Plan Commission Meeting Agenda

TOWER DRIVE CONDOMINIUMS PHASE 1
SECTION 14, TOWNSHIP 10N, RANGE 12E

Ruekert & Mielke, Inc. has completed our review of the site plan for the above referenced project, with an application date of July 15, 2026. The submittal was reviewed in accordance with Columbus Ordinance Chapter 90 - Subdivision and Chapter 114 - Zoning, Chapter 47 - Erosion Control and Chapter 48 - Storm Water Management. This review does not constitute a recommendation for future phases. Future phases for development on this lot shall require additional review and approval. This review may not include all City requirements for this submittal. We offer the following comments, clarifications, or concerns:

UTILITY PLAN

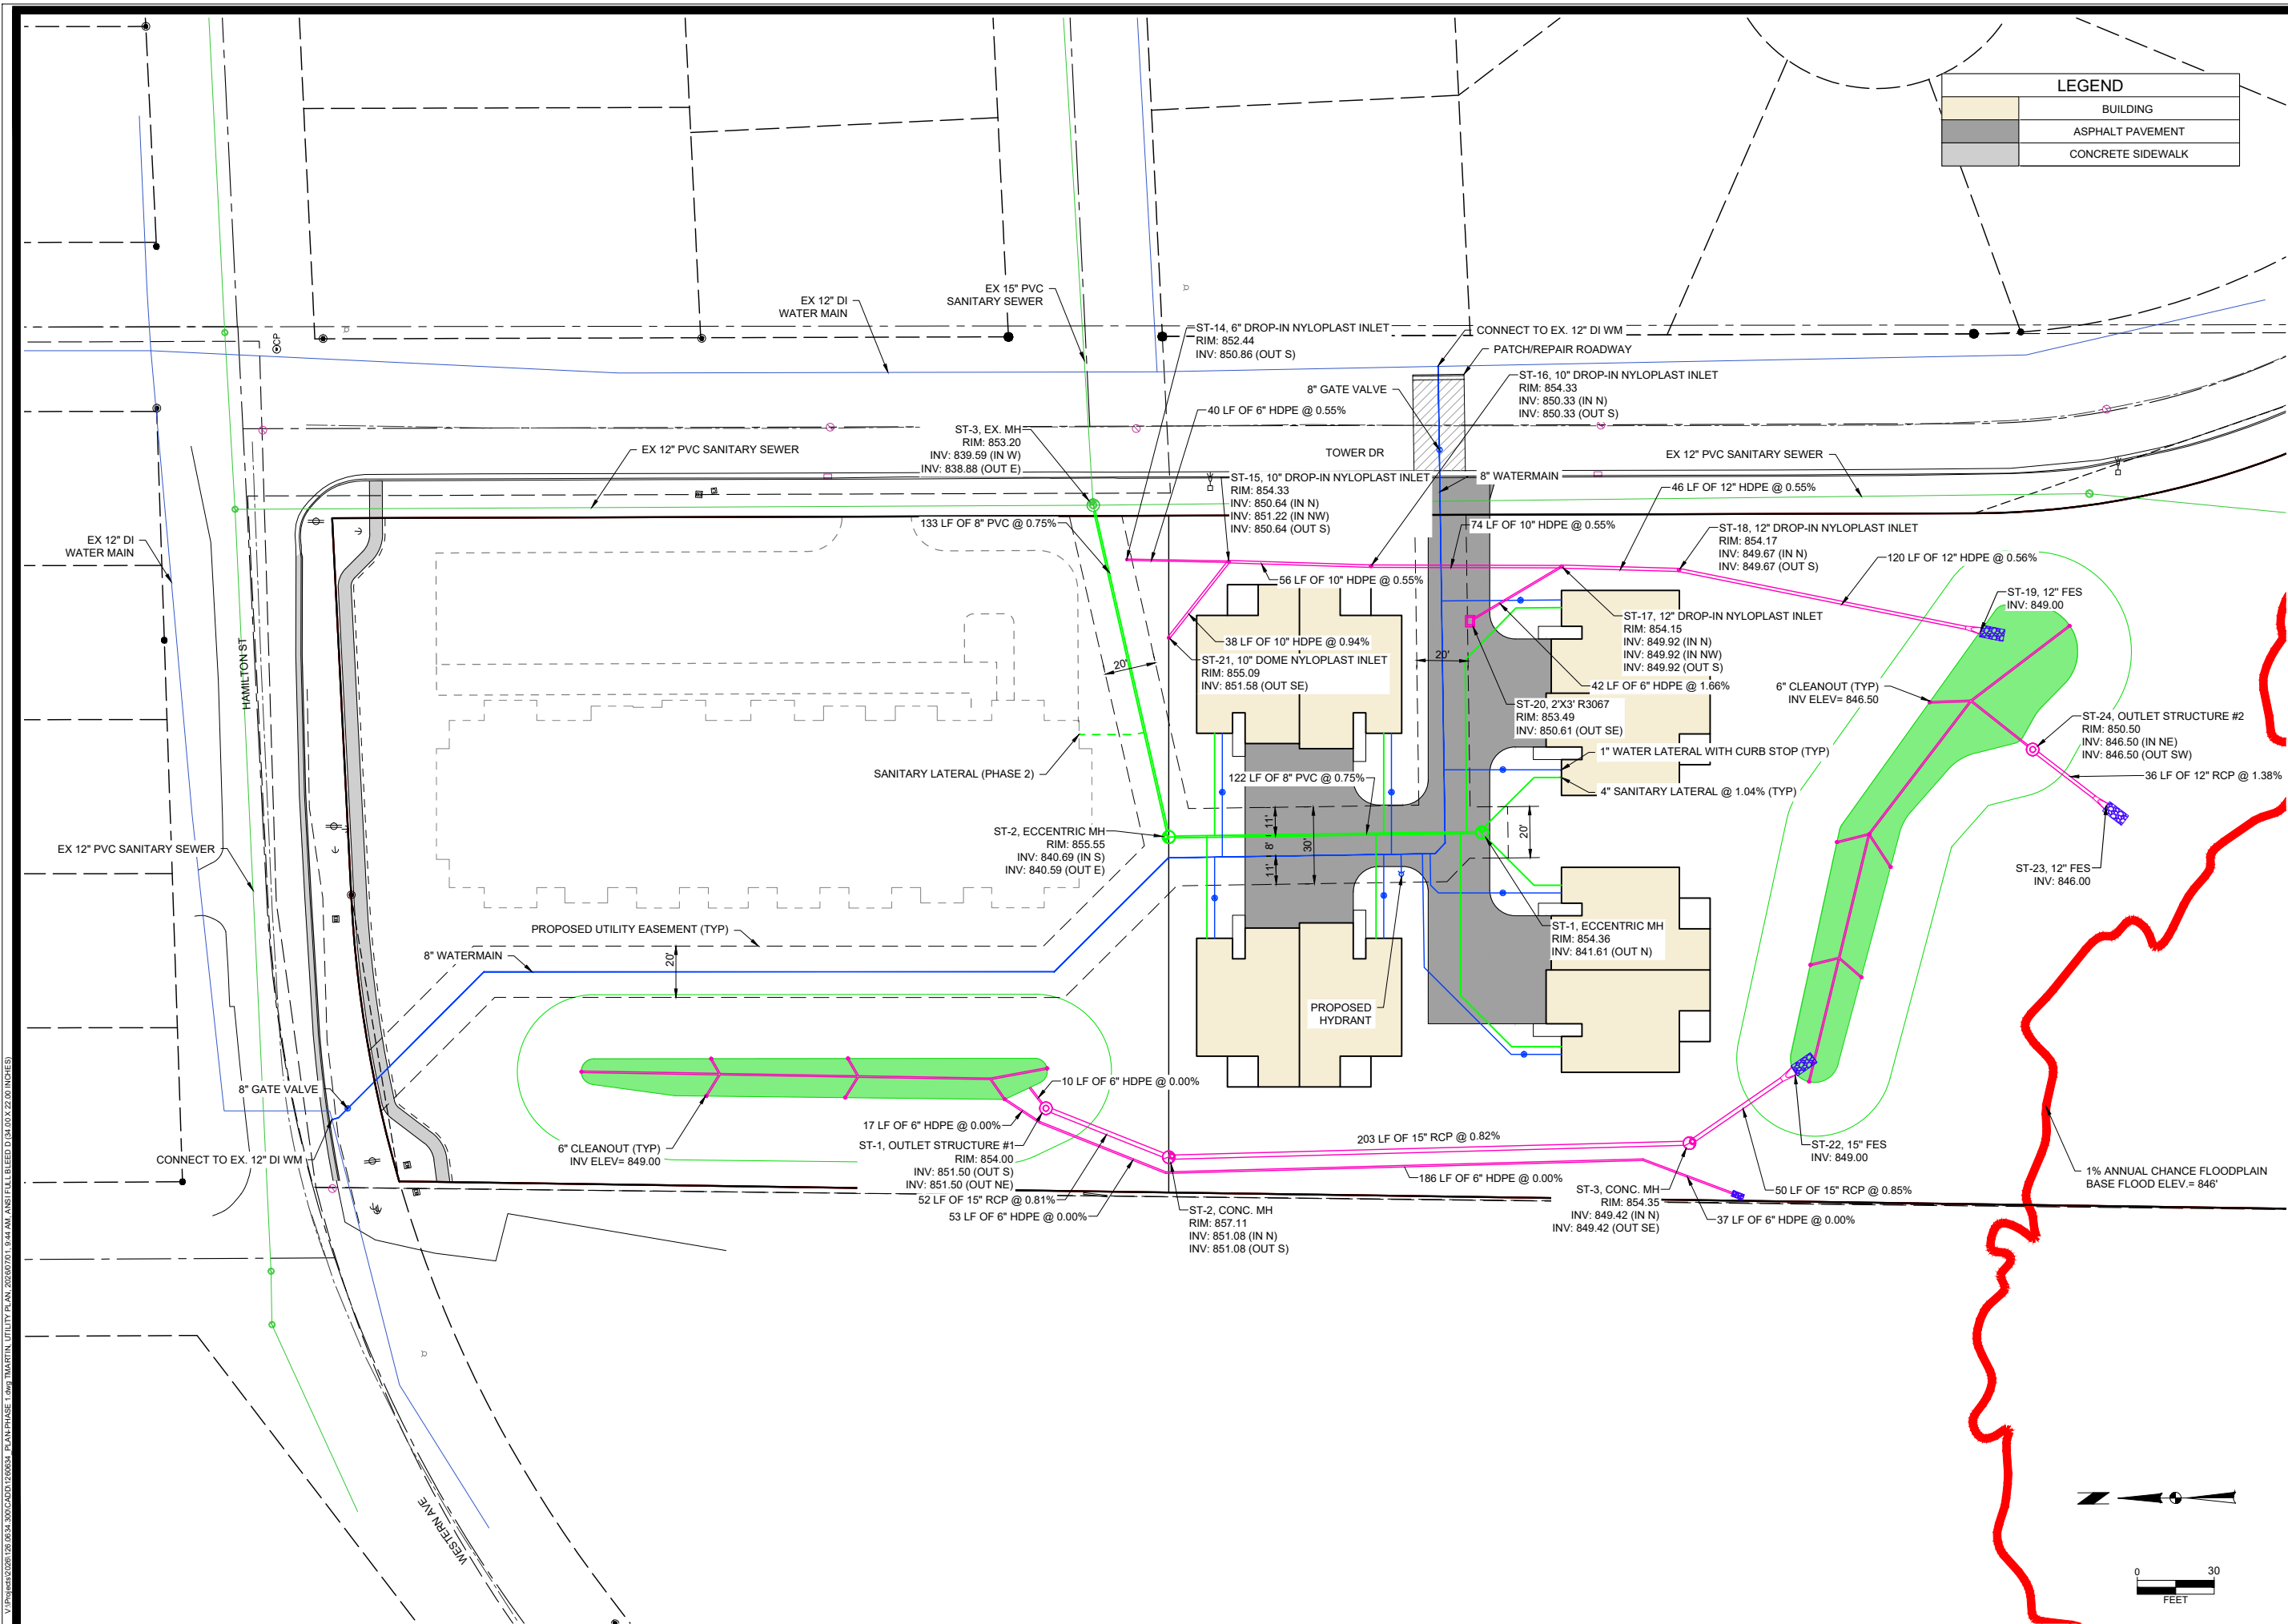
1. Existing sanitary sewer manhole shall be cored, booted and new bench formed in bottom for new connection.
2. Install phase 2 sanitary sewer lateral stub with phase 1 construction.
3. Verify long sewer laterals for lot 2 do not need cleanouts.
4. Provide note with detail on proposed tie-ins to existing watermain. Live tap both water main connections with existing 12 inch water main.
5. Move valve closer to tap location on Tower Drive

6. Add valve on 8 inch to isolate phase 1 and future phase 2 near sanitary manhole 2.
7. Please call out angles of proposed watermain bends.
8. Show insulation on all water main crossing with storm sewer on plan.

9. WDNR public water plan review and permit will be required for this project.
10. WDNR public sanitary sewer plan review and permit will be required for this project.

11. Is the intent for the phase 2 building do be connected to the proposed watermain? If so, please add their lateral with a valve in this design. Please size accordingly to meet fire flow requirements for the buildings sprinkler system.

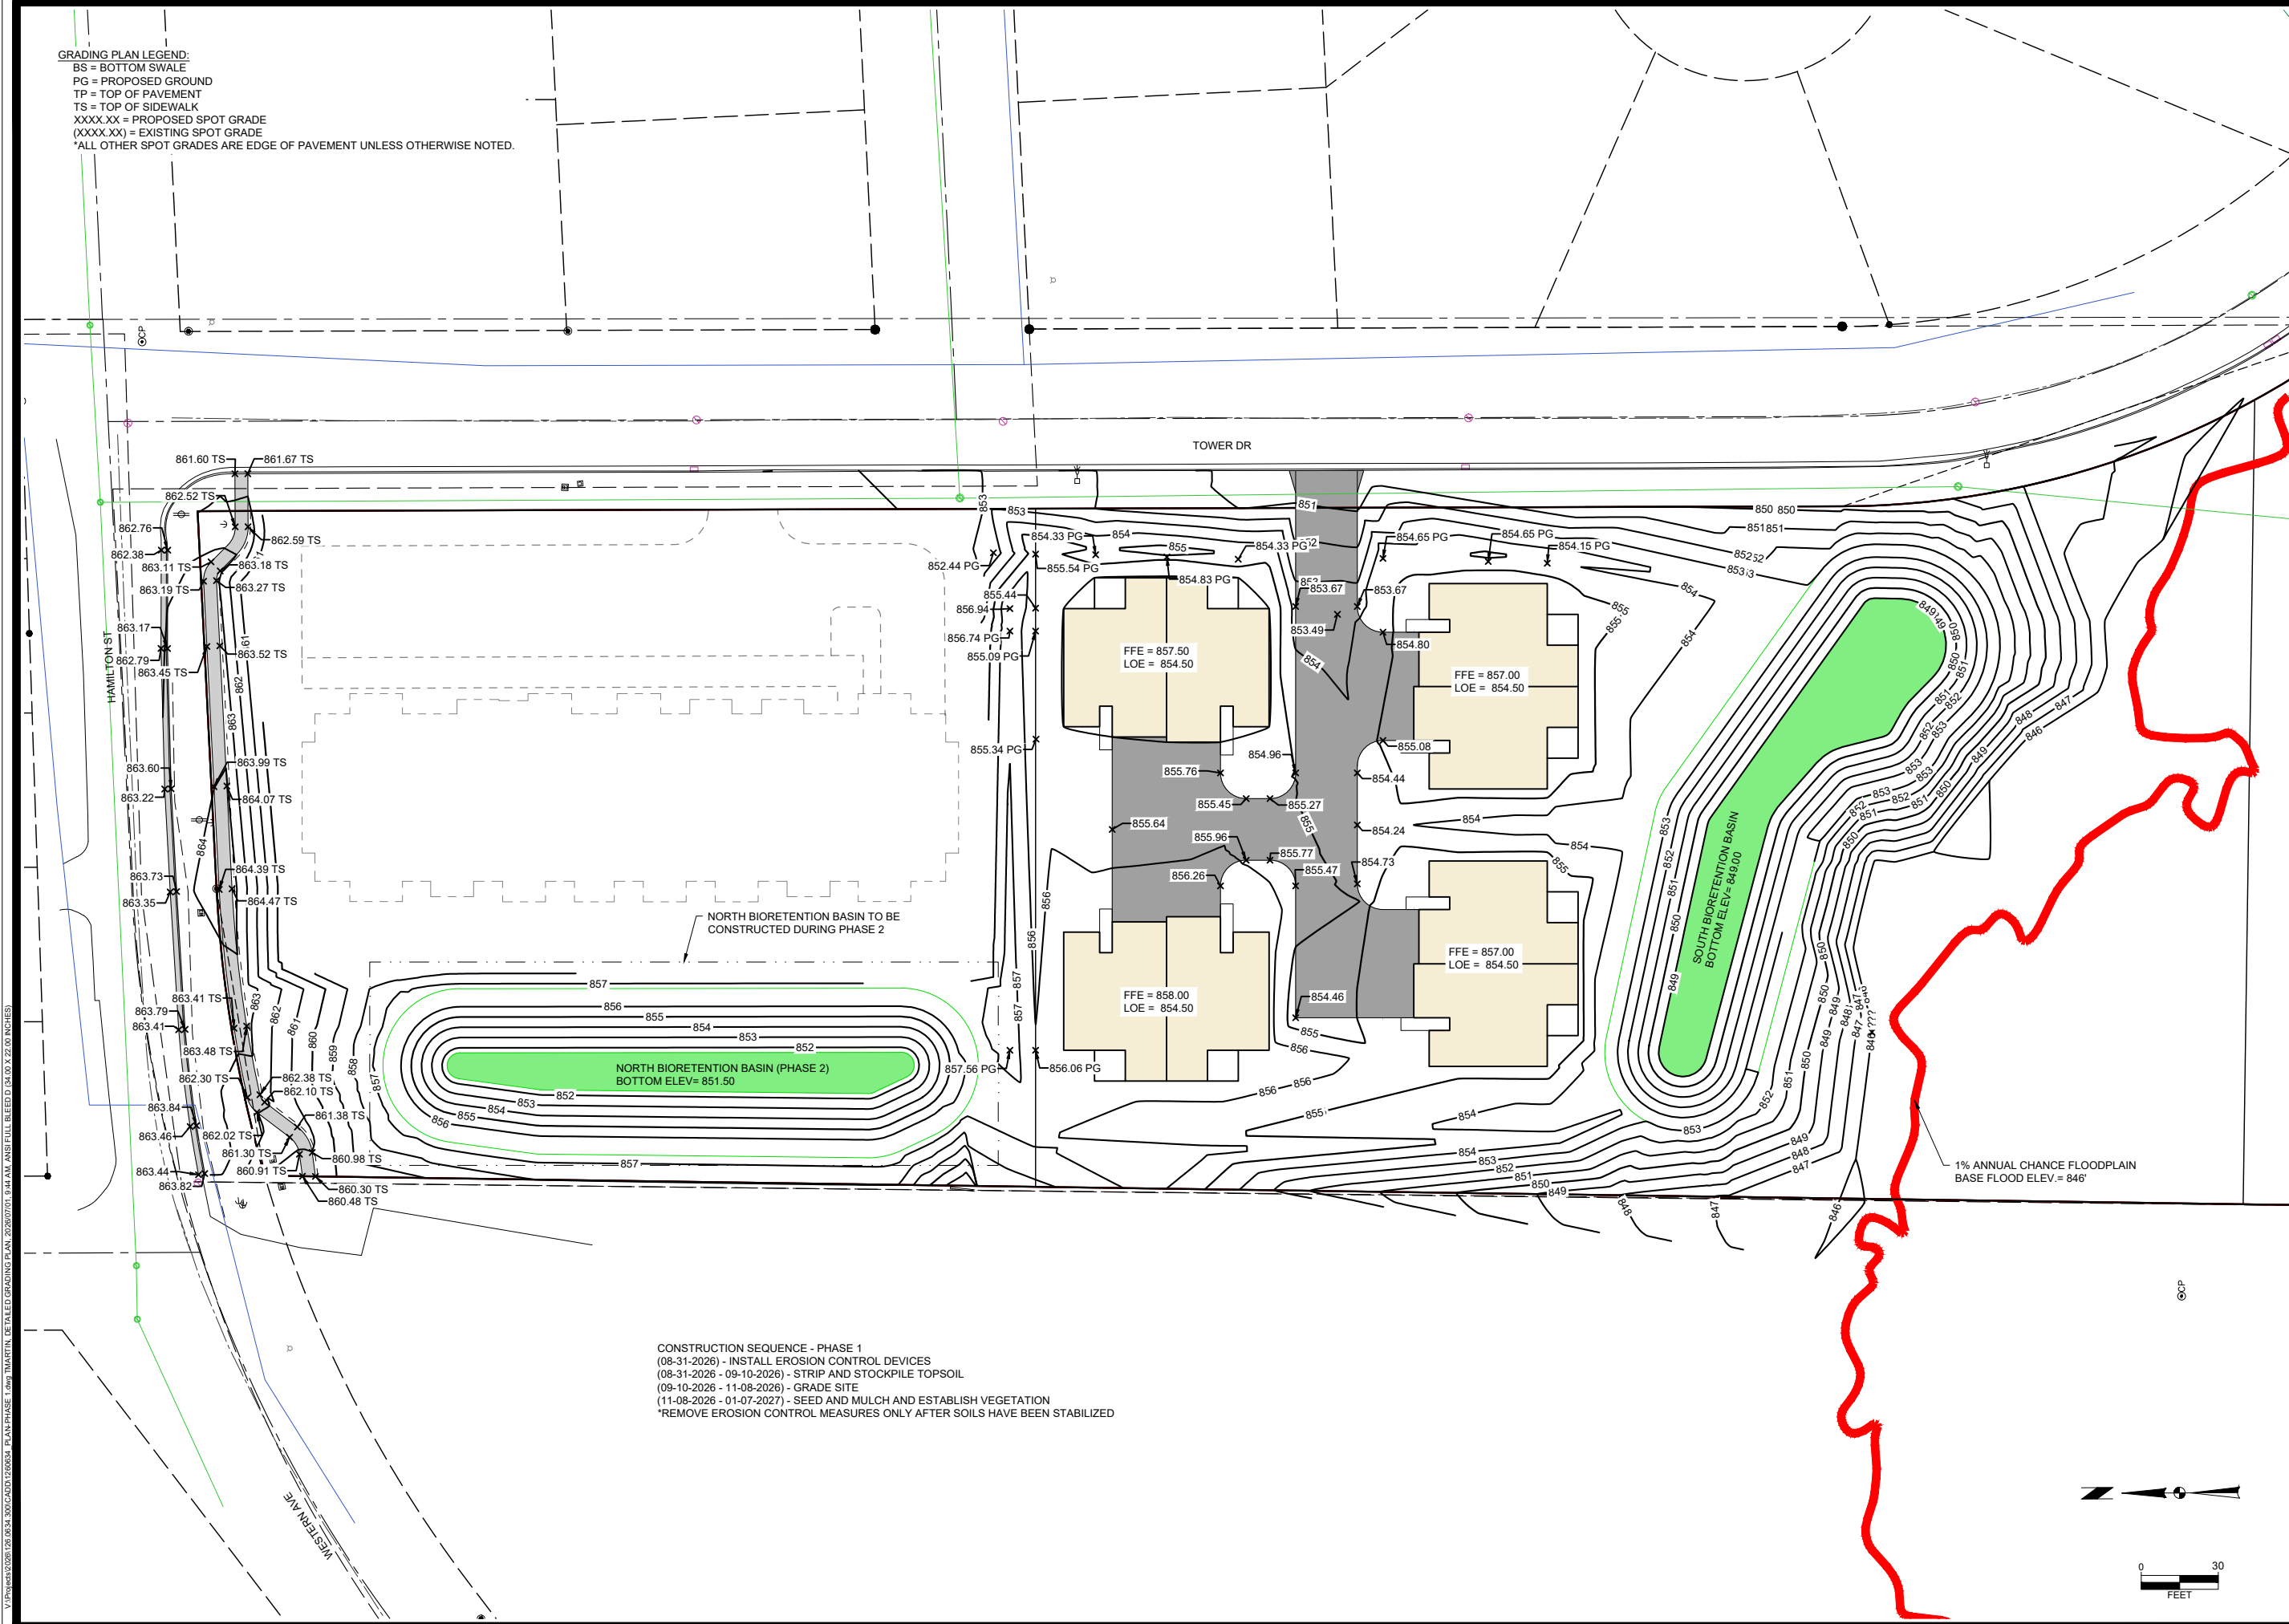
1. ST – 20 need to catch water draining towards street, revise contours and rim elevation. Casting is R3067, define as flat top.
2. Appears that grading will be filling up to 1.5 feet of fill where existing utility boxes are located along Western Ave. In past project there was a significant cost to relocation utility boxes, confirm if you intend to fill in that area and or adjust / relocate boxes.
3. The terrace is shown to be regraded along a portion of Tower Drive, confirm intent and why this is proposed.
